In Re:
INTERCONNECTION REGULATIONS

Case no. NEPR-MI-2019-0009

REPLY TO LUMA'S APRIL 22, 2024 RESPONSE TO URGENT REQUEST

SMART INVERTER SETTINGS SHEETS

Figure 2-2. Example Volt-Watt characteristics

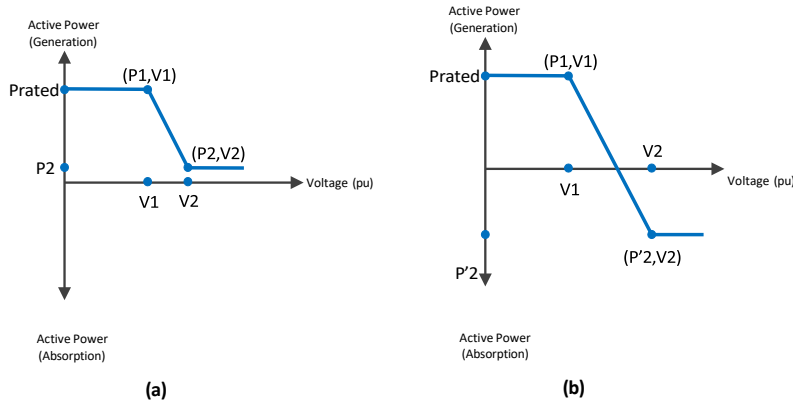
Commented [U26]: Change to DEACTIVATED by default.

Commented [U27]: It's important to understand that when Volt-Watt is activated for an inverter, it means that when the voltage in their neighborhood gets 6% higher than normal (so since normal voltage is 120 Volts, 6% higher is 127.2 Volts), when the voltage reaches 127.2 Volts, then the amount of solar output to the grid starts being reduced ("curtailed"), and that it curtails more the higher the voltage goes. So when voltage reaches 106% of normal, the solar output is reduced by 20%; with voltage is 107% of normal, it's reduced by 40%, when it's 108% it's reduced by 60%, when it's 109% it's reduced by 80%, and when it's 100%, the customer's solar system is not able to export any solar power to the grid at all.

* By default, this control mode will be deactivated except where a supplemental study requires it implemented because of high DER penetration to support local distribution equipment upgrades that will be performed in a timely manner. After upgrading the local distribution equipment, this setting may be deactivated upon request with approval from LUMA.

Further detail: * By default, this control mode will be deactivated except where a supplemental study requires it implemented because of high DER penetration to support local distribution equipment upgrades that will be performed in a timely manner. After upgrading the local distribution equipment, this setting may be deactivated upon request with approval from LUMA.
